Key Information	Details
Application No:	PA1900648-1
Permit Allows:	Buildings and works for the development of two dwellings and removal of native vegetation
Land Address:	11 The Avenue, Mt Buller (Lease Site 17)
Amendment Received:	15 January 2026
Statutory Days:	137
Applicant:	Joe Grech c/- Human Habitats
Planning Scheme:	Alpine Resorts
s72 Proposal Summary:	Summary: The applicant proposes to amend the architectural plans to revise the building footprint, design and layout to include 5 dwellings (apartments) in lieu of the approved 2 dwellings. Includes at grade car parking in lieu of the approved car stackers. Includes the removal of one additional native tree (Tree No. 24). The applicant seeks the following changes to the endorsed plans/documents: Supersede: - Architectural plans, prepared by David Liddiard & Associates and endorsed on 11 March 2022 (28 sheets) - Bushfire Management Statement, prepared by Terramatrix and endorsed on 11 March 2022 (19 sheets) - Site Environmental Management Plan (SEMP), signed by Anthony William Peterson and endorsed on 11 March 2022 (12 sheets) - Arboricultural report, prepared by Oldmeadow Arboriculture and endorsed on 11 March 2022 (21 sheets)

Figure 2: Currently endorsed and proposed west elevations (view from street frontage) (Source: Endorsed architectural plans & Application material)

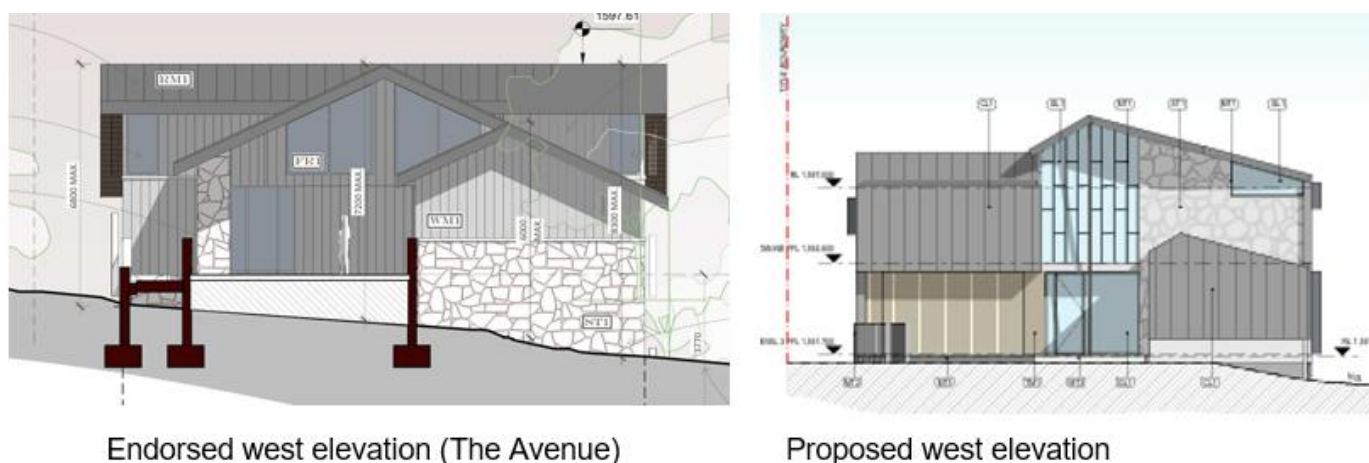
5. A comparison of currently endorsed and proposed elevations is provided at Figures 2 to 5.

Figure 6: Plan of trees to be removed (Source: Application)

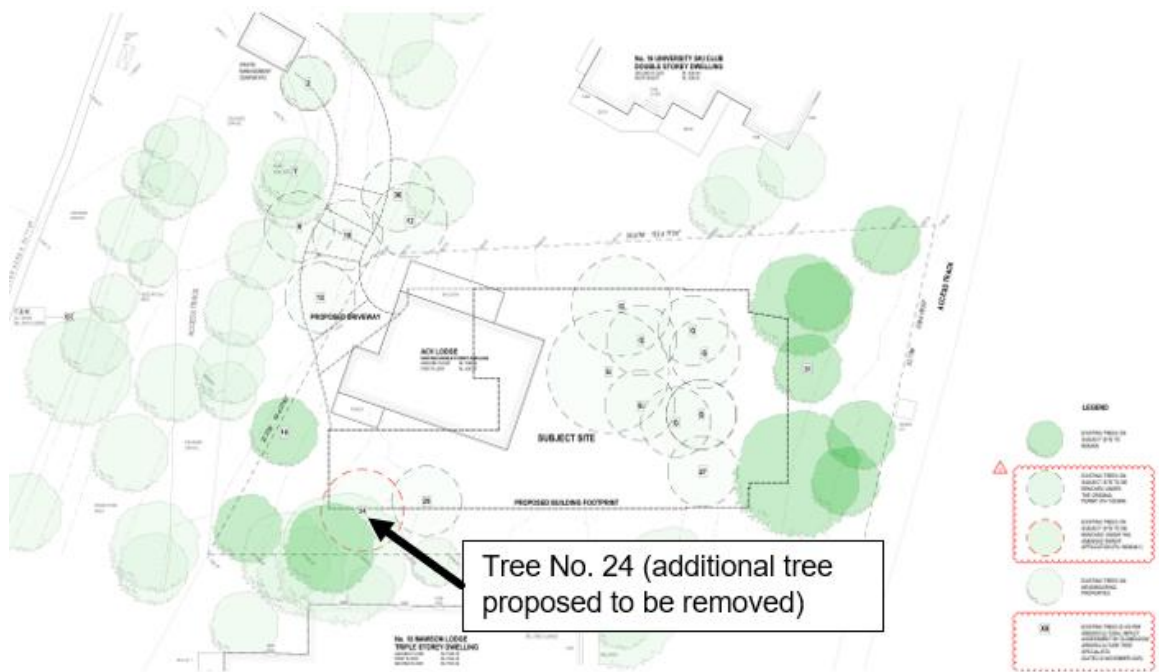
6. One additional tree is proposed to be removed, (as stated within the submitted planning report), namely Tree No. 24, located to the south/west corner of the proposed building footprint. (It is noted that the architectural plans identify two additional trees to be removed, namely Tree No's 12 and 36 however the submitted arboricultural report indicates these trees can be retained. As such, it is considered that this was an error and therefore a condition of any amended permit to issue will require the architectural plans to be amended to reflect retention of Tree No's 12 and 36. Refer to Figure 6 for tree removal plan.

71. However, a discrepancy appears on the architectural plans submitted with the application as the plans incorrectly show Tree No's 12 and 36 as trees previously approved under the original permit for their removal. This is incorrect because these two trees are clearly not identified as trees permitted to be removed. Figure 6 includes Tree No's 12 and 36 as

trees permitted to be removed under the original permit. Figure 10 below includes the trees permitted to be removed under the original permit. Figure 10 does not show Tree No's 12 and 36 and as such their removal has not been approved.

- Condition 1i will require the retention of Tree No's 12 and 36 and their protection during construction. The architectural plans incorrectly identify that permission was already granted for their removal under the original permit, however this is incorrect. As such, a new condition will require their retention and protection during construction, as identified in the submitted arboricultural report.

Figure 8 – Building height analysis showing area above 11 m height (Source: Application)

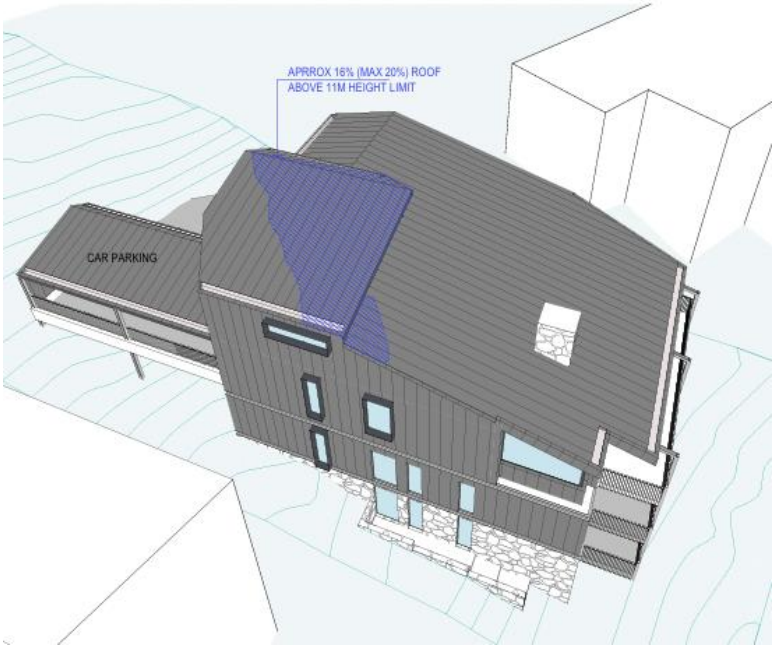
<table><tr><th>DDO1-A1</th><th>Requirement</th><th>Assessment</th></tr><tr><td>Maximum height</td><td> <i>The maximum height of any part of a building is 3 storeys or 11 m above natural ground level, whichever is the lesser height.</i> <i>A permit may be granted to increase the height of any rooftop structure or chimney by 1.5 m, provided no more than 20 per cent of the roof area exceeds 11 m in height.</i> <i>A permit may be granted to vary maximum heights.</i> </td><td> Variation sought: The maximum height to the amended plans is approximately 12 m, which is marginally higher than the approved plans of 11 m for the building plus chimney. However, approximately 16% of the roof area exceeds 11 m in height, which is within the permissible area. Refer to Figures 8 and 9 for a building height analysis and a cross-section showing the extent of area exceeding 11 m. The variation is minor and considered reasonable given the height variation is easily under the maximum permitted height of 12.5 m and the area exceeding 11 m is generally located towards the middle part of the building, thus results in minimal impact to neighbouring properties, given the setbacks to the adjoining properties exceed 4 m. </td></tr></table>

Figure 10 – Trees permitted to be removed under original permit (shown dashed) (Source: Endorsed architectural plans for PA1900648)

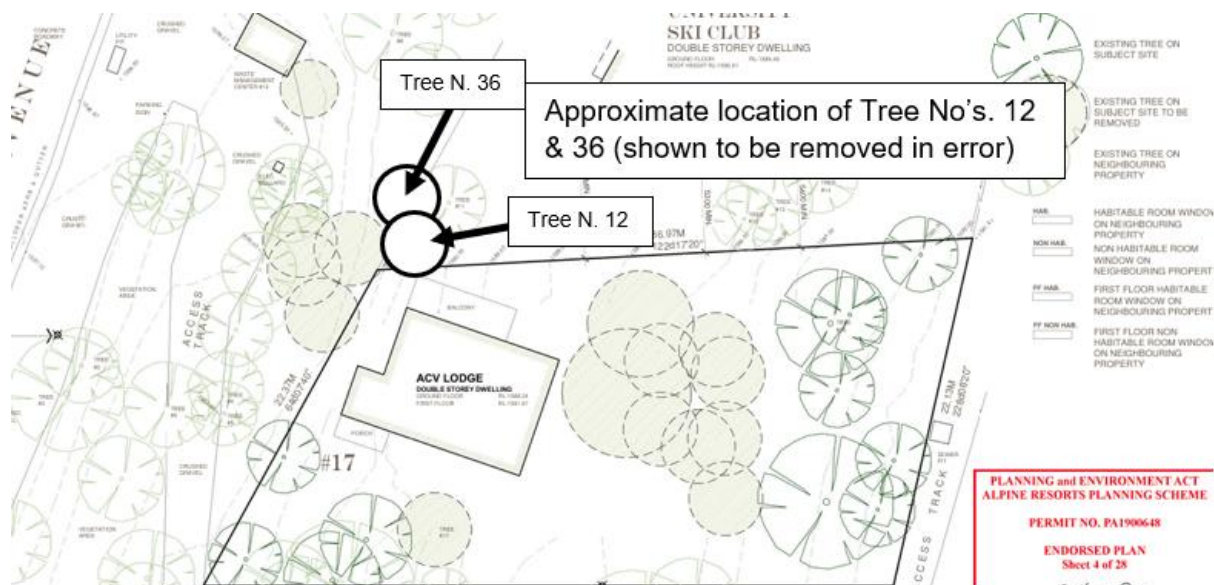
72. A review of the arboricultural report indicates that both trees in question can be considered as 'lost' however can be retained. The report recommended that with minimised excavation and installation of protective fencing during development, these trees can be retained. As such, a condition of any amended permit to issue will require Tree No's 12 and 36 be shown as retained and protected.
